SYDNEY WESTERN CITY PLANNING PANEL

TO: Sydney Western City Planning Panel
REPORT: SWCPP Addendum Report
SUBJECT: 62-74 Canley Vale Road and 19-21 Phelps Street, Canley Vale
FILE No: DA 139.1/2025

Application lodged	13 May 2025
Applicant	On the Park Square Pty Ltd
Owner	On the Park Square Pty Ltd
Application No.	DA 139.1/2025
Description of Land	<p>Lot: 2A DP: 420389 - 62 Canley Vale RD, CANLEY VALE Lot: 3 DP: 22203 - 62 Canley Vale RD, CANLEY VALE Lot: 1A DP: 420389 - 68 Canley Vale RD, CANLEY VALE Lot: A DP: 398409 - 70 Canley Vale RD, CANLEY VALE Lot: 10 DP: 969 - 72 Canley Vale RD, CANLEY VALE Lot: 1 DP: 947762 - 74 Canley Vale RD, CANLEY VALE Lot: 4 DP: 22203 - 19 Phelps ST, CANLEY VALE Lot: B DP: 398409 - 19 Phelps ST, CANLEY VALE Lot: 5 DP: 22203 - 21 Phelps ST, CANLEY VALE</p>
Proposed Development	<p>Demolition of existing structures, site preparation works and the construction of a three (3) storey commercial building comprising:</p> <ul style="list-style-type: none"> • Supermarket; • Commercial Premises; • Food and Drink Premises; • Gymnasium; and, • Basement carpark and loading facilities. <p>This application also seeks consent for the supermarket anchor tenant, signage

Figure 1 – South elevation - original

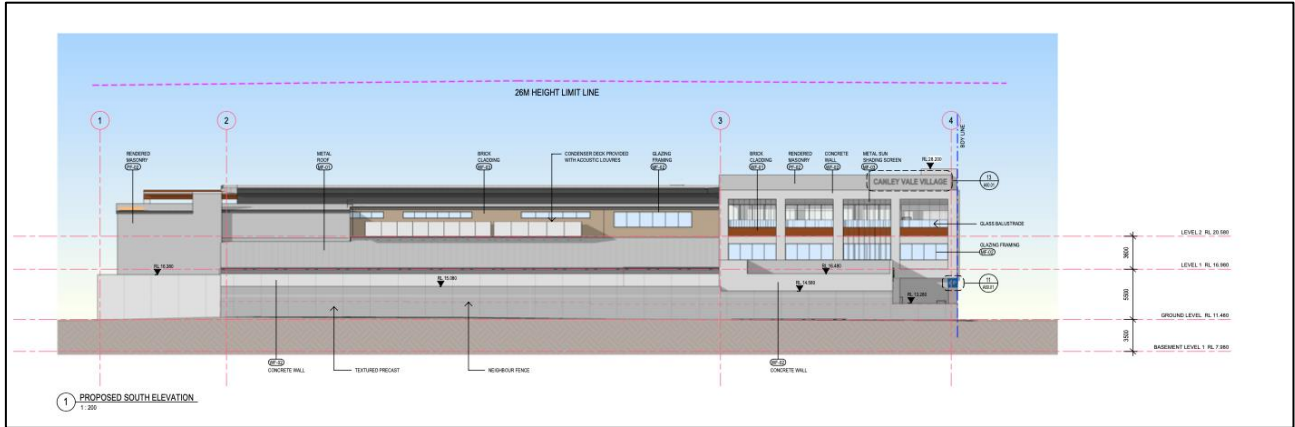
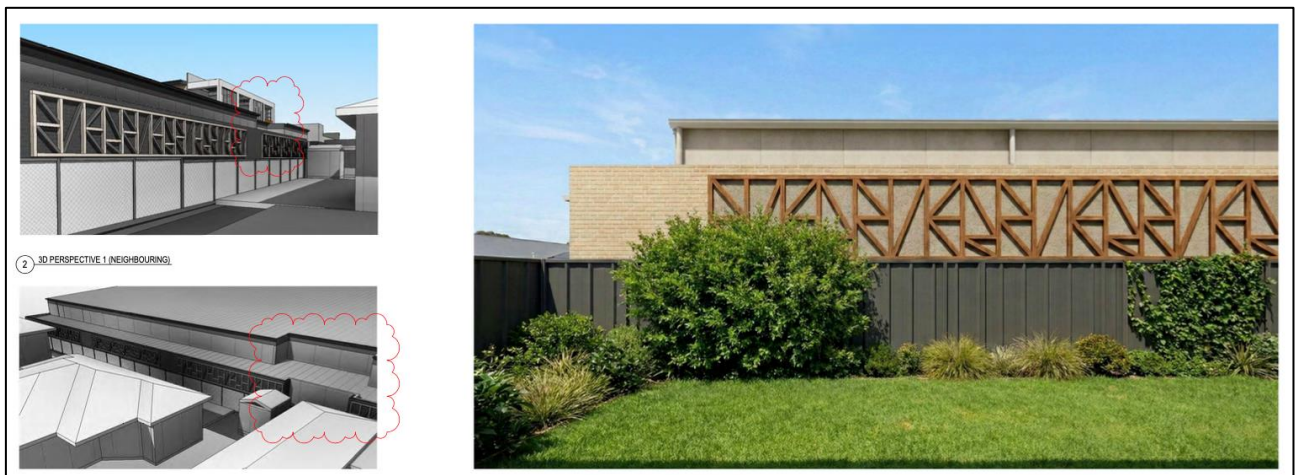
- Southern elevation.

The amended plans have introduced a brick cladding and timber look panels to break up the expanse of precast concrete. This considered to provide an improved backdrop to the residences along

Phelps Street and Pevensey Street, and is considered to offer a satisfactory treatment of the interface between the development and its neighbours.

This matter is resolved by the amended plans.
